CERTIFICATE OF APPROPRIATENESS PLACARD

600 LEONIDAS COURT

042-15-MW

Raleigh Historic Development Commission – Certificate of Appropriateness (COA) Application

Photograph:

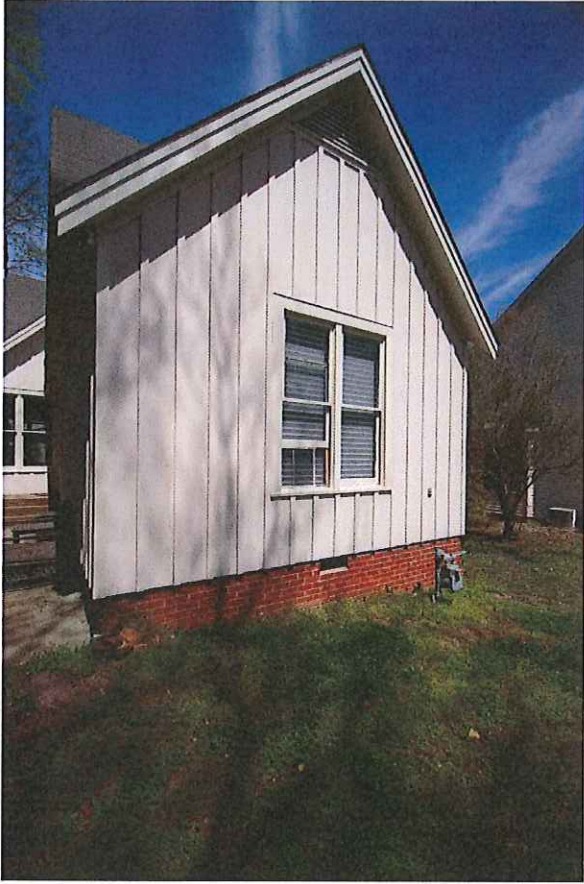
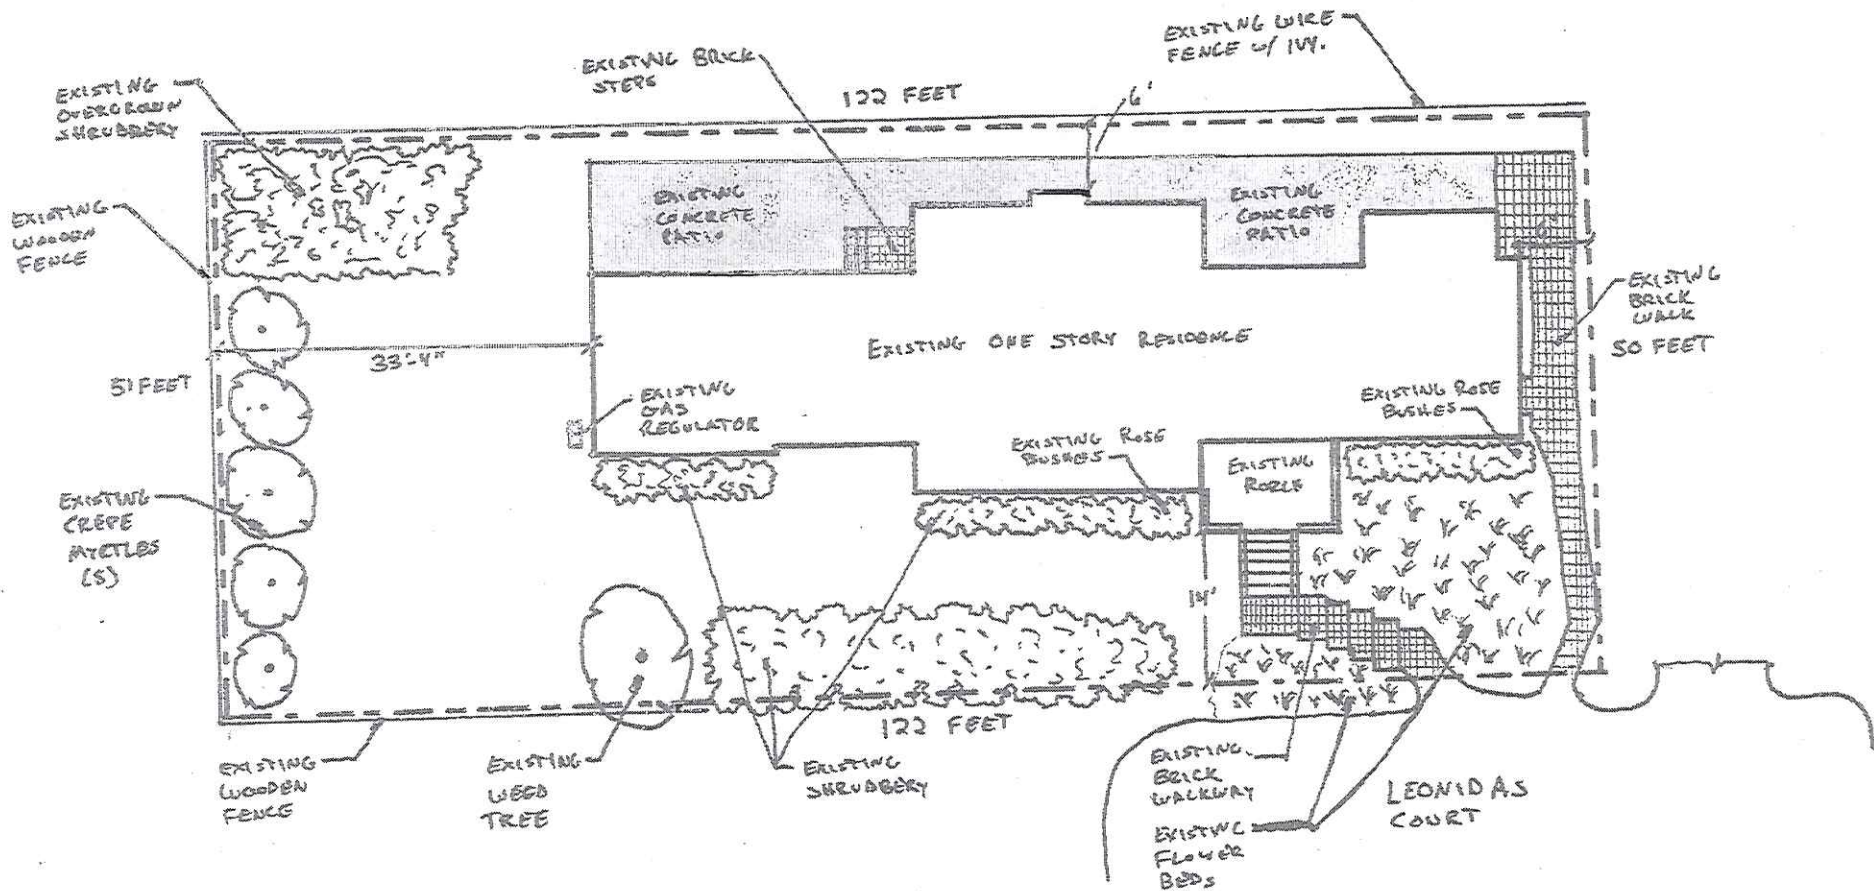
← not regulated

removal of trees < 8" DBH do not require COA.

PROPOSED SITE PLAN

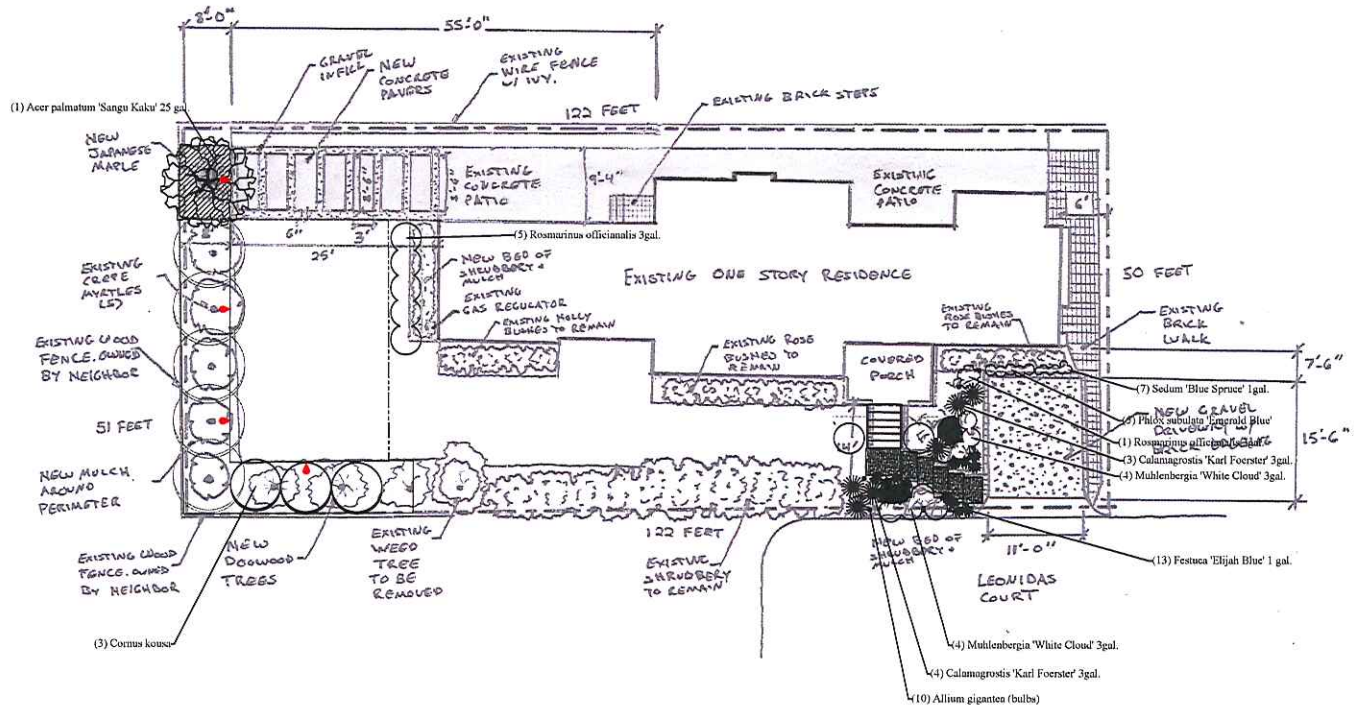
- Please include pictures and spec sheets (when available) for the mortared brick edging, footlights, and floodlights.
- Please delineate the placement of footlights and floodlights on a plot plan.
- What is the size (DBH) and species of the "weed" tree proposed for removal?
- Use of *stone steps do not clearly meet the guidelines and is not approvable by staff. The steps shown as an example in the application do not have an approved COA on file.*
- The illumination of specimen trees does not clearly meet the Guidelines and is not approvable by staff.

- Please include pictures and spec sheets (when available) for the mortared brick edging, footlights, and floodlights.
- Please delineate the placement of footlights and floodlights on a plot plan.
- ✓ What is the size (DBH) and species of the "weed" tree proposed for removal? — *4/13/15 Per phone conv, less than 8dbh*
- Use of stone steps do not clearly meet the guidelines and is not approvable by staff. The steps shown as an example in the application do not have an approved COA on file.
- The illumination of specimen trees does not clearly meet the Guidelines and is not approvable by staff. *re-review 2.7 & OK 161*

- 4) I am proposing additions to the exterior lighting.
 - a. **Add (4) four discreet recessed footlights around the back yard to subtly illuminate select plantings. See red light symbols on updated site plan and attached fixture cut sheet for clarity. These fixtures were selected to align with those shown in the bottom left image of the lighting portion of the Design Guidelines for Historic Districts (Section 2.7, page 20).**

• Red dots = lights

Thanks for taking the time today to talk through my application. Please find attached, my updates, in red, to the written description, site plan, and light fixture cut sheet. These edits should encompass everything that we discussed earlier. Please let me know if there are any more adjustments I need to make. Thanks again for your help.
